Subject: **ACTIVE TRANSPORTATION PROGRAM – PROJECT SCOPE  
AMENDMENT AND SEGMENTING – DELAWARE STREET SAFE ROUTES TO  
SCHOOL CORRIDOR PROJECT  
RESOLUTION ATP-P-2425-11**

# Project Scope Change and Segmenting Request Caltrans' Analysis and Recommendations

**PROJECT NAME:** Delaware Street Safe Routes to School Corridor

**Exhibit 25-D: Request for Project Scope Change (Local ATP Projects)**

TRAFFIC SIGNAL PLAN - BERMUDA DR  
DELAWARE STREET  
SAFE ROUTES TO SCHOOL  
CITY PROJECT NO. 46R022

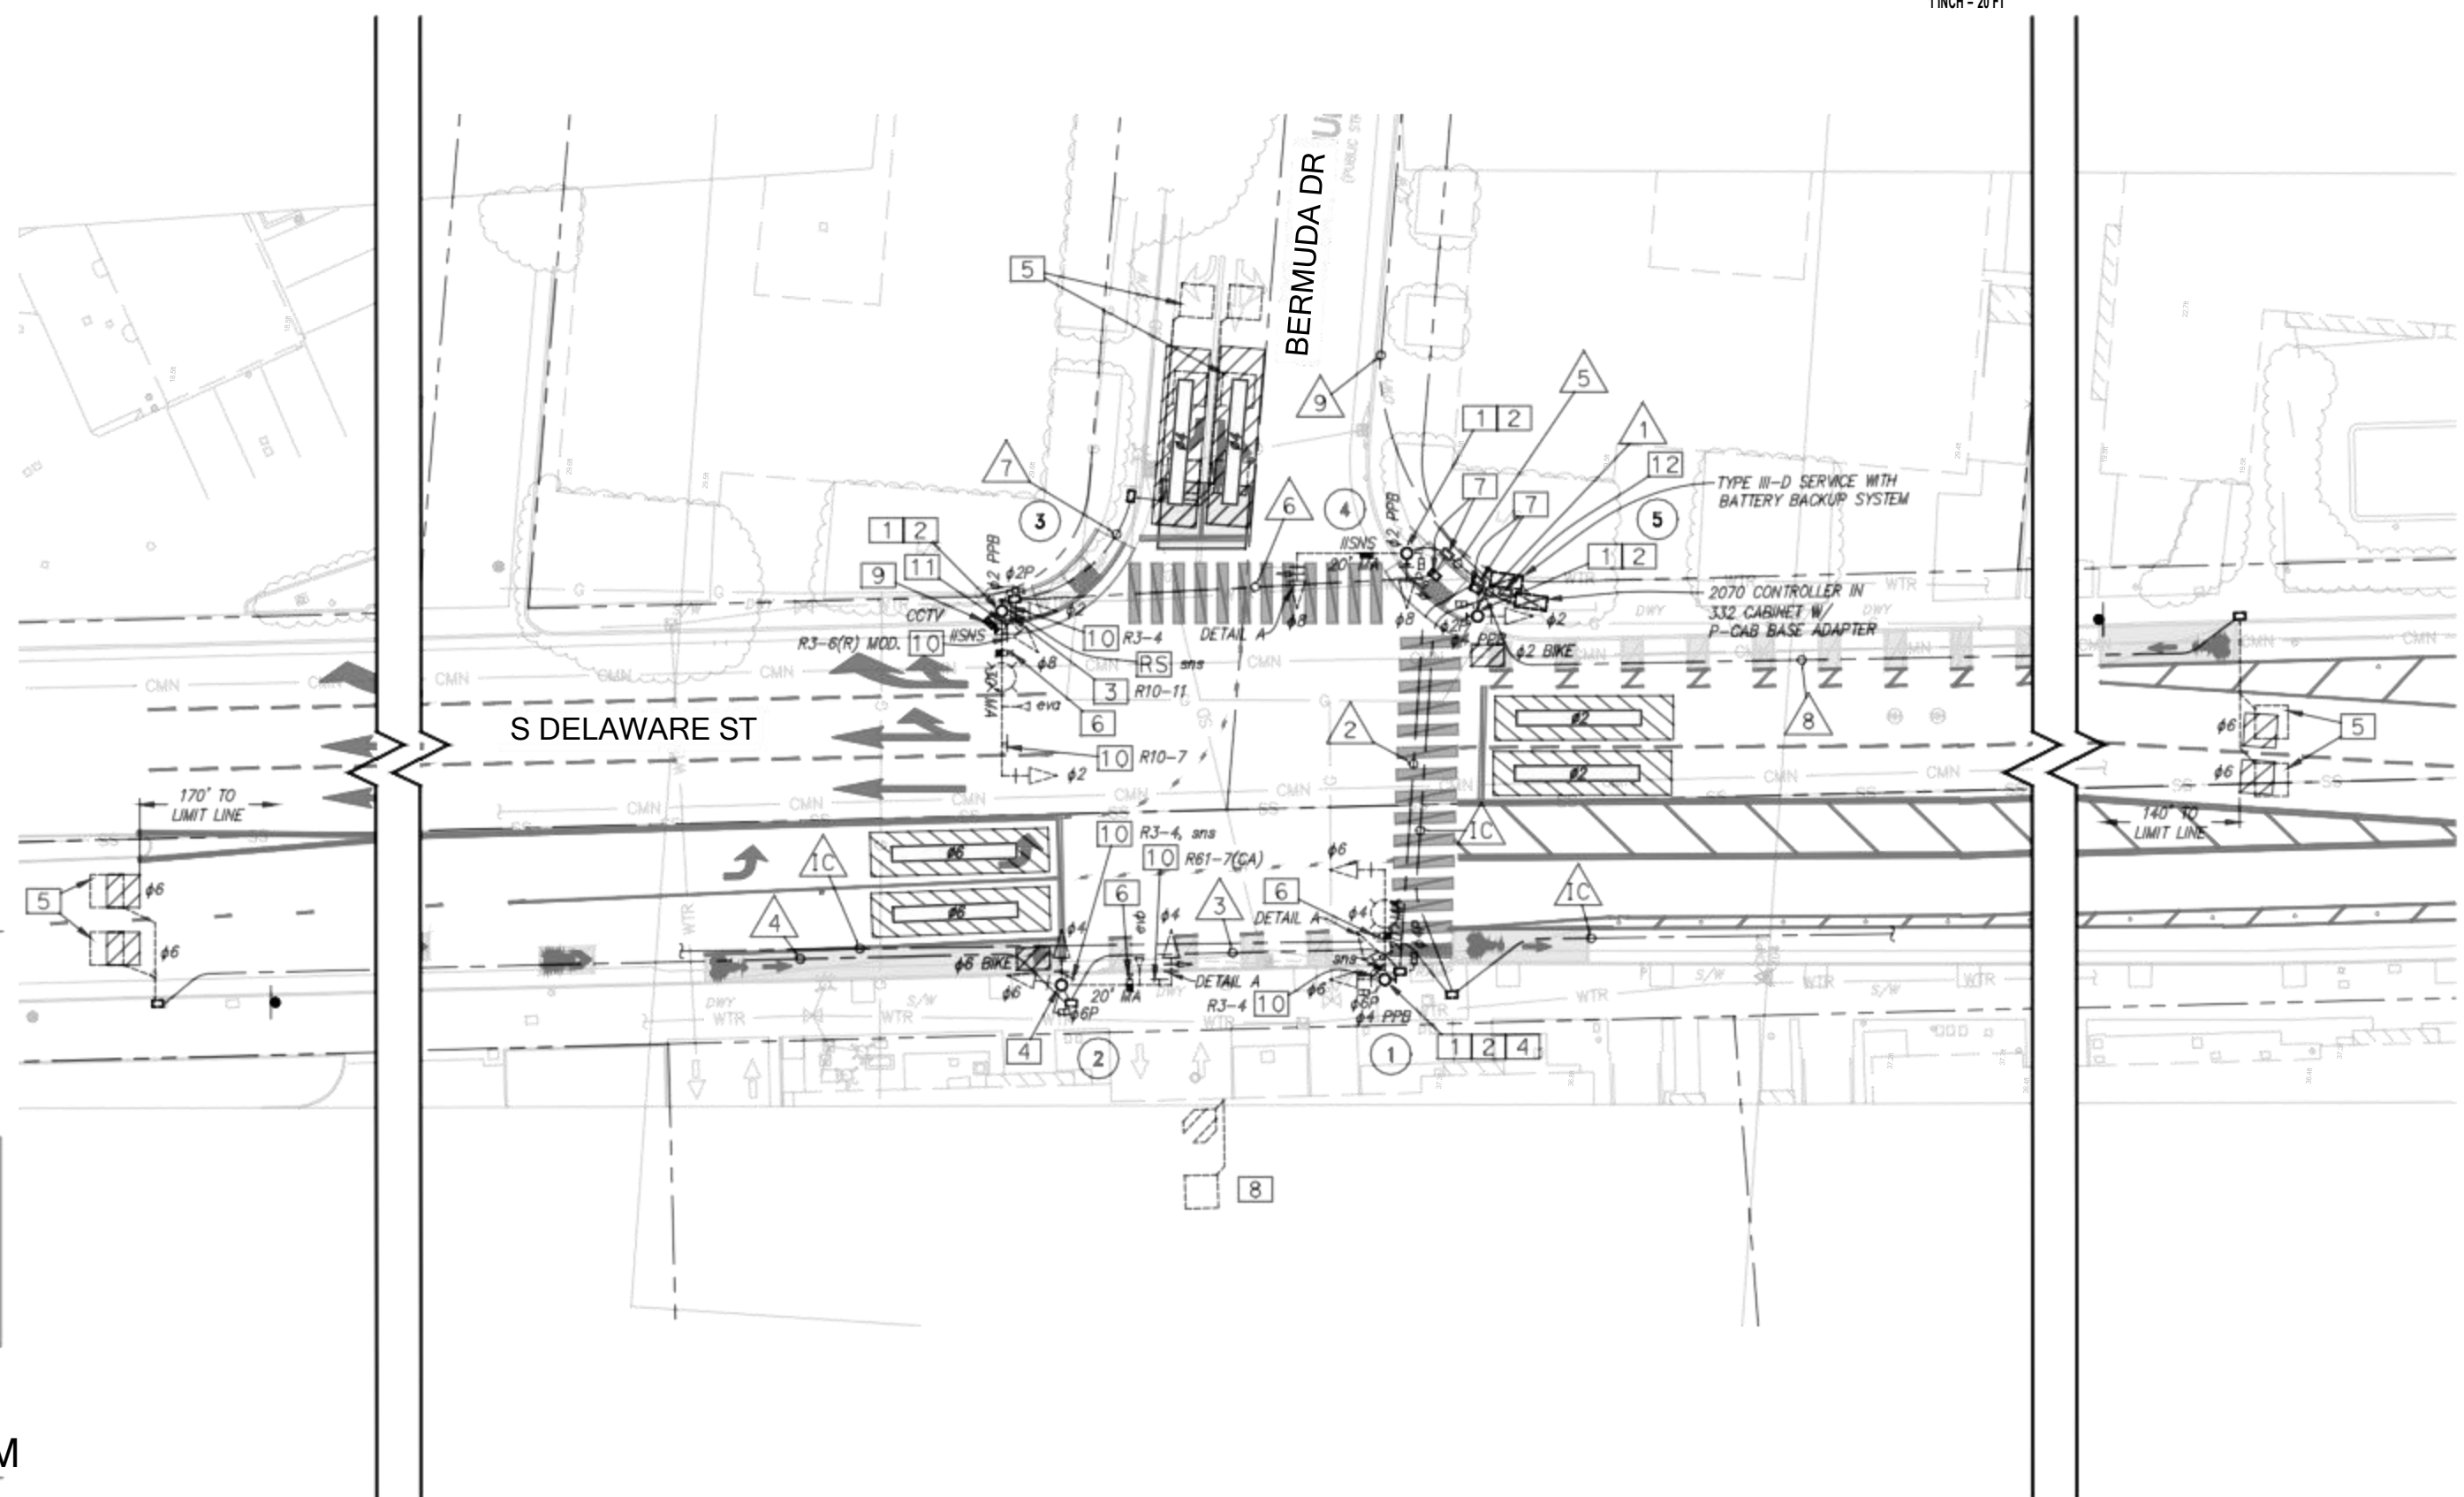
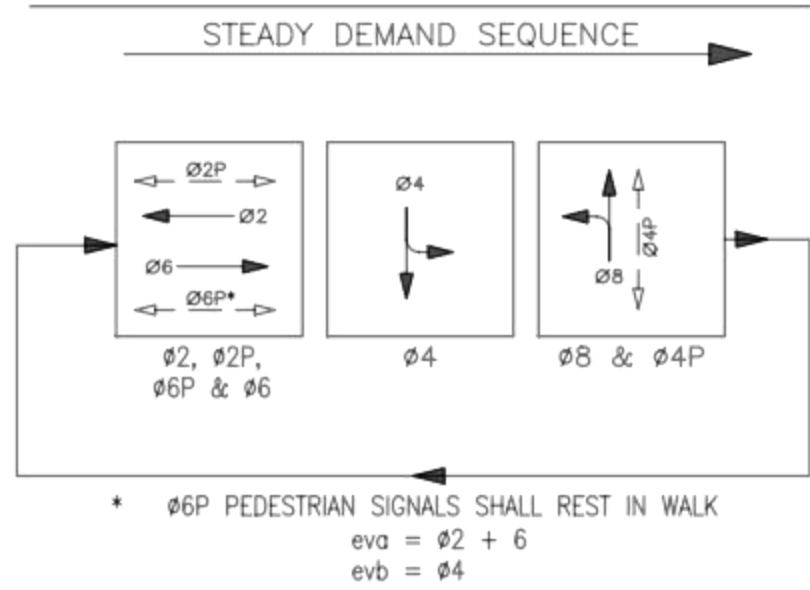
1. At Bermuda Dr, Saratoga Dr, 25th Ave and 28th Ave
  - Add intersection timing changes to 4 intersections
2. At Delaware St and Pacific Blvd intersection
  - Add Rectangular Rapid Flashing Beacon (RRFB) and crosswalk improvements

Change 1- the agency is utilizing local funds to determine timing improvements/signal improvement needs along the entire project corridor.

- b) The reason for the proposed scope change (CON only, see (1)(b)(i)) is due to an understanding that the provision of Class IV bike lanes along this corridor would also require careful design considerations<sup>1</sup> for the City's intersections, meaning that a corridor analysis needed to be performed to be able to understand operational considerations pre/post-project for the existing signalized intersections.

**RRFB PLAN - PACIFIC BLVD  
DELAWARE STREET  
SAFE ROUTES TO SCHOOL**

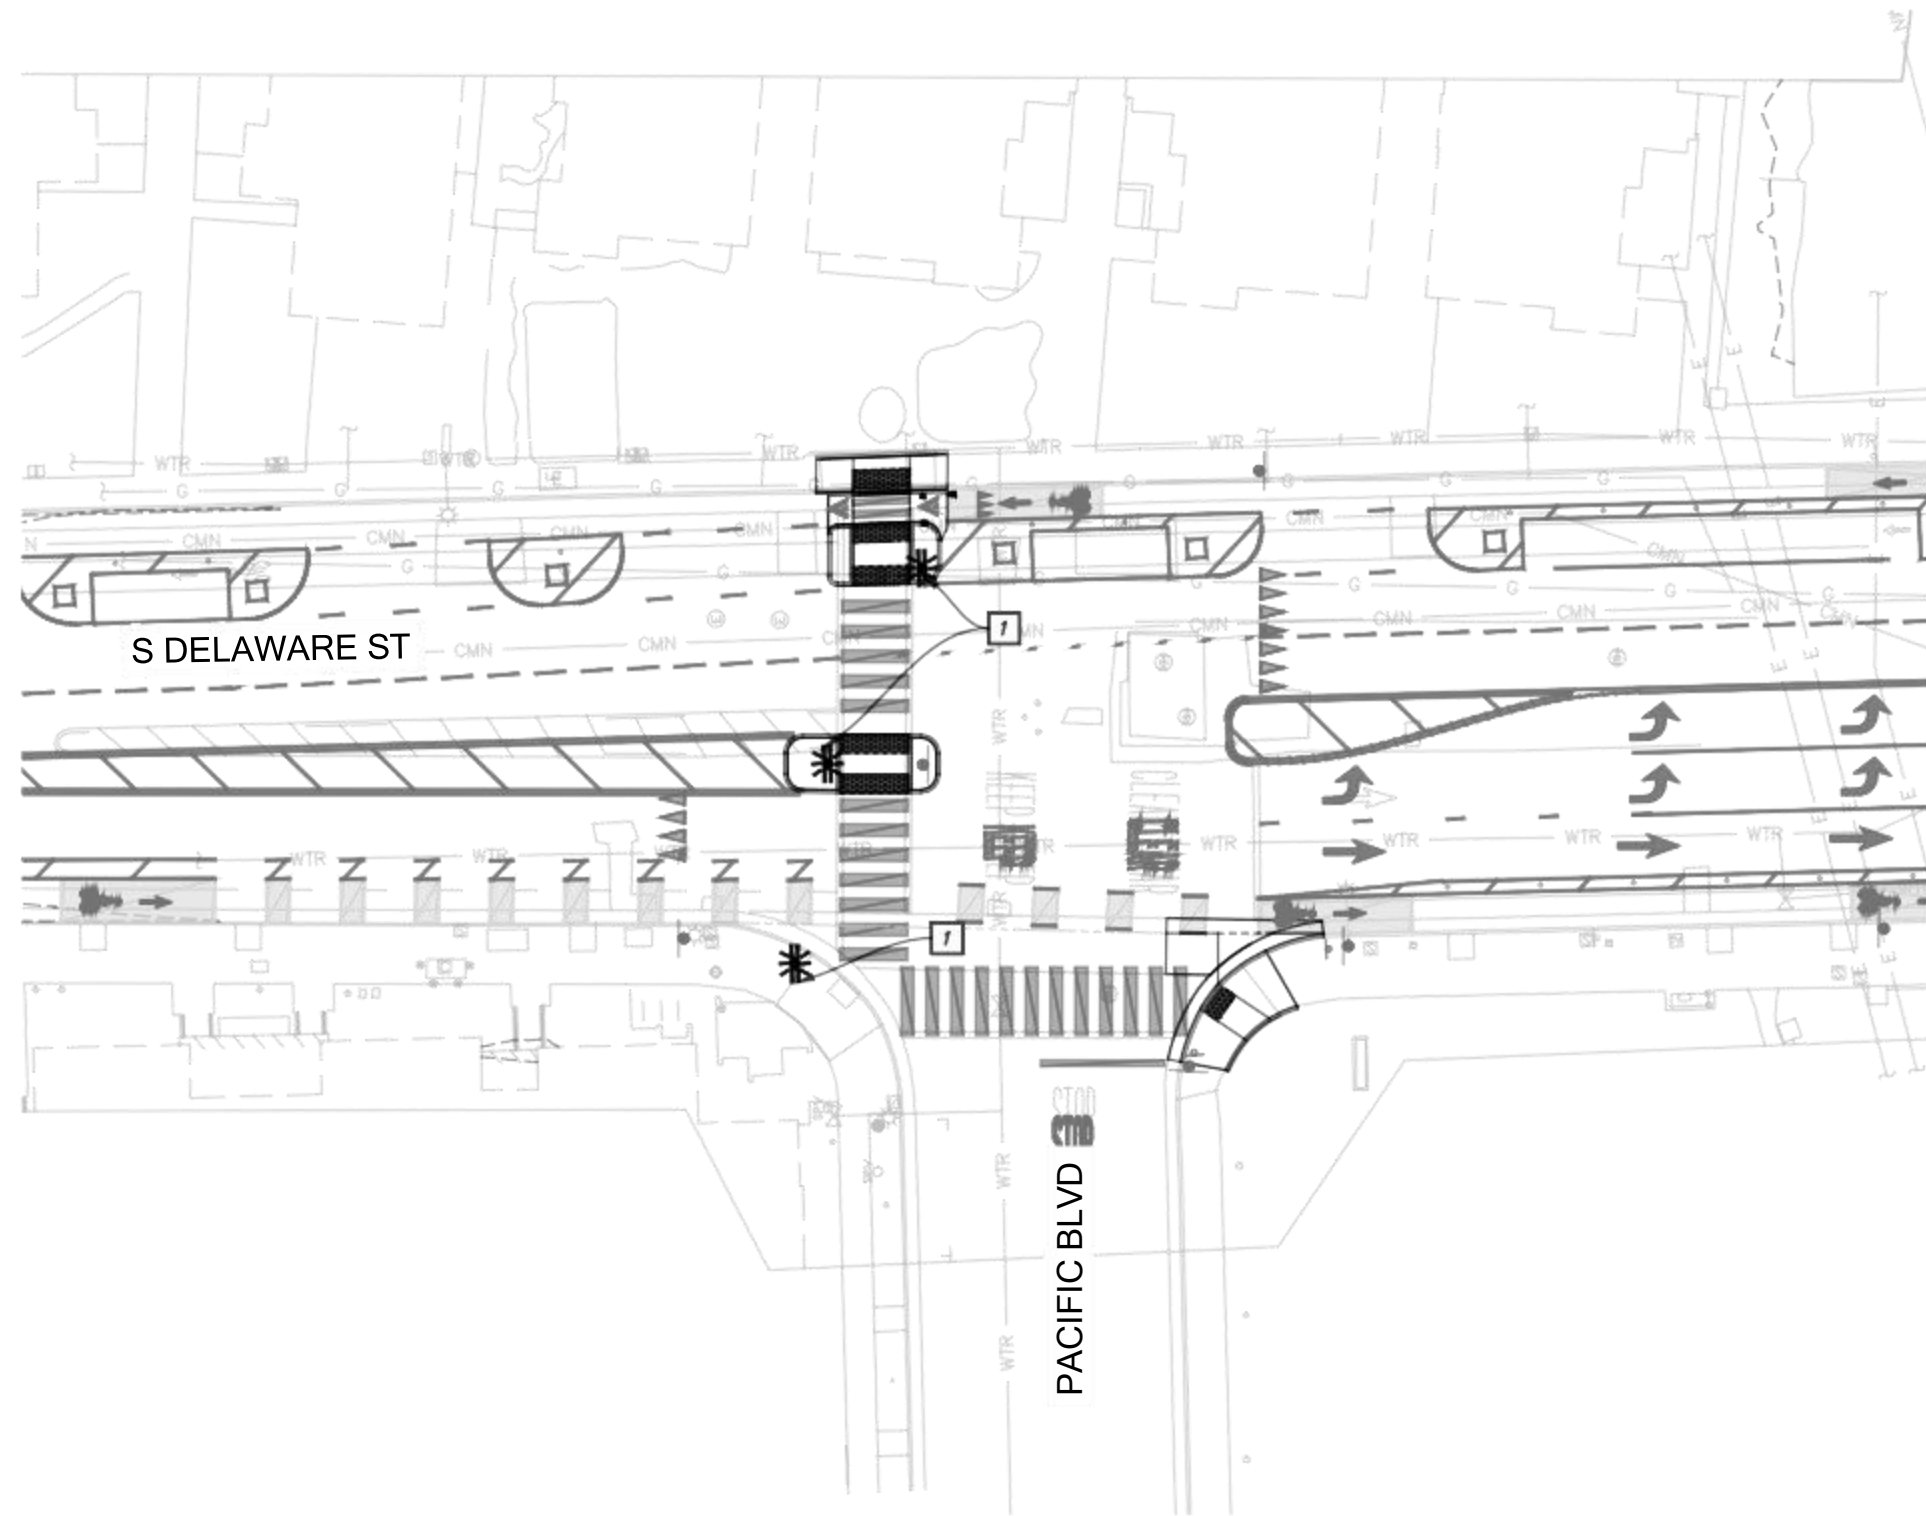
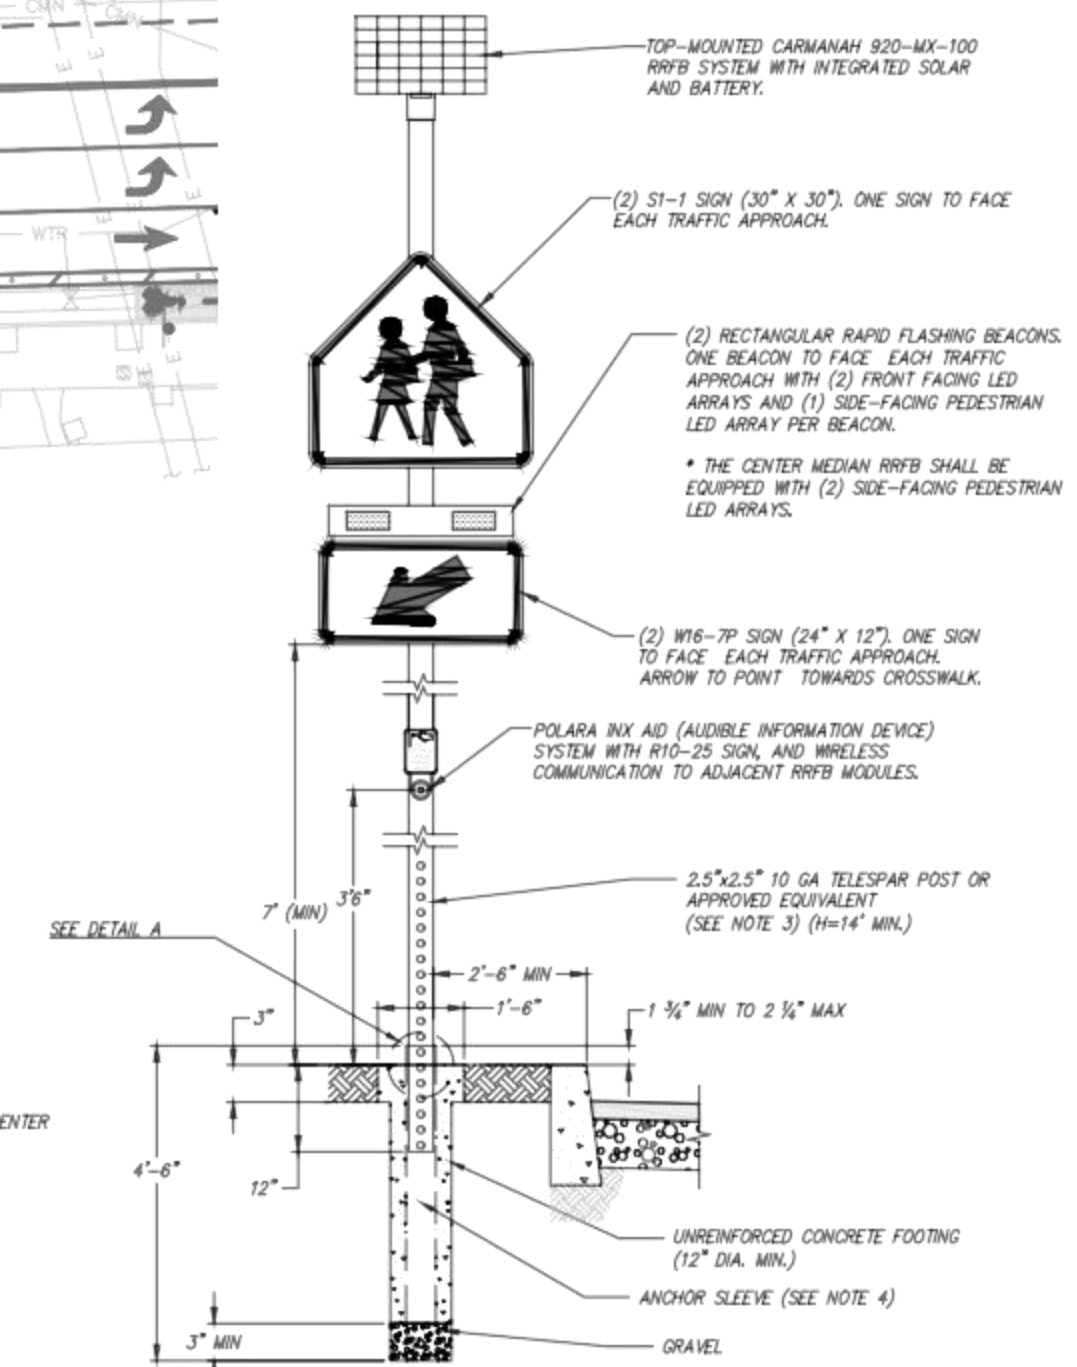
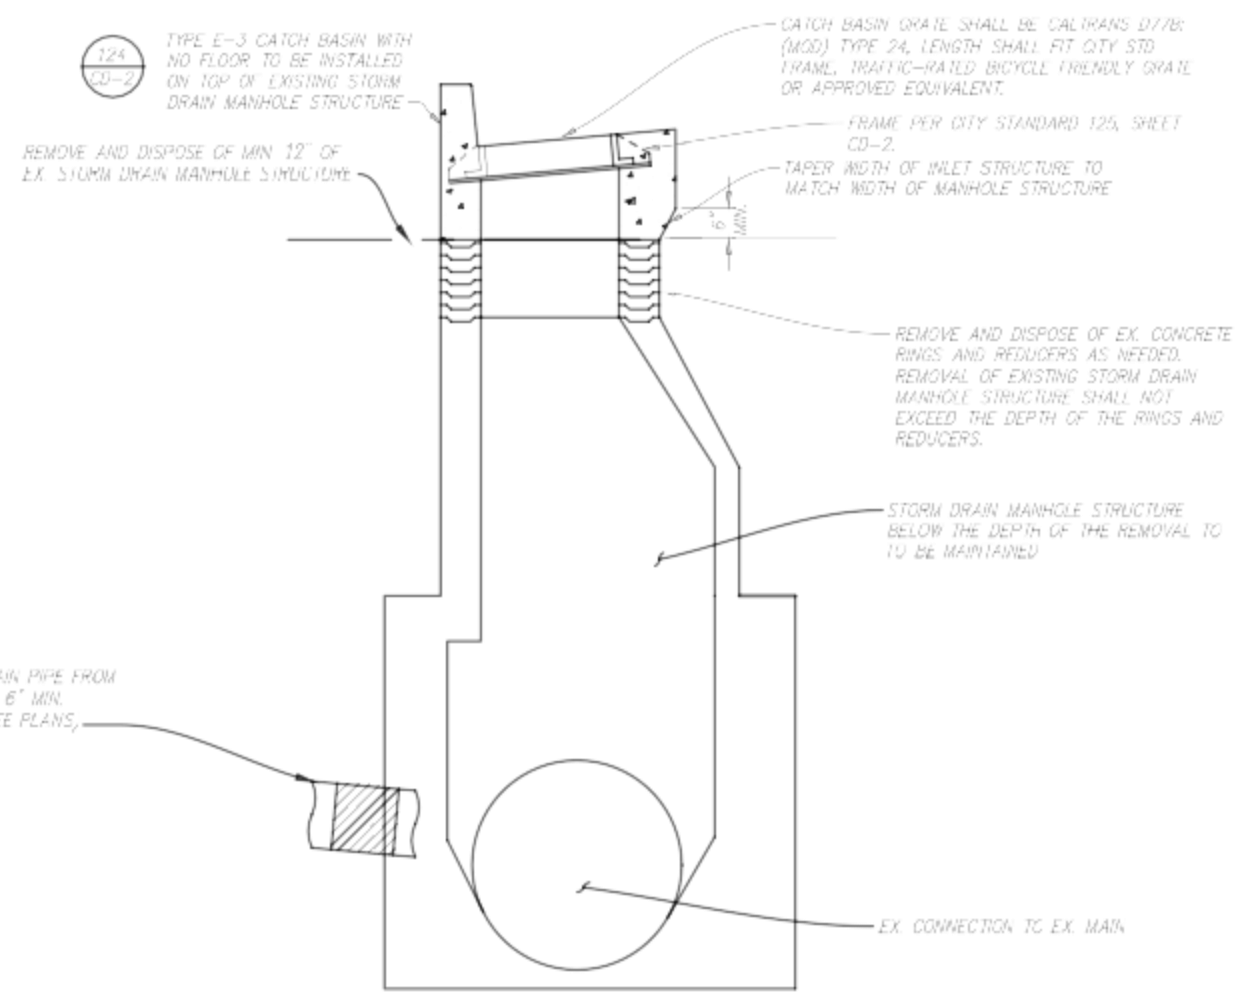
Change 2- the agency wants to add ATP enhancements to the intersection.

- c) The reason for the proposed scope change is due to a desire to enhance both bike/ped safety of this crossing while providing an option for cyclists headed NB to more easily make the connection to the Hayward Park Caltrain station until the bike lanes associated with the US 101/SR 92 Mobility Hub & Smart Corridor project are implemented.
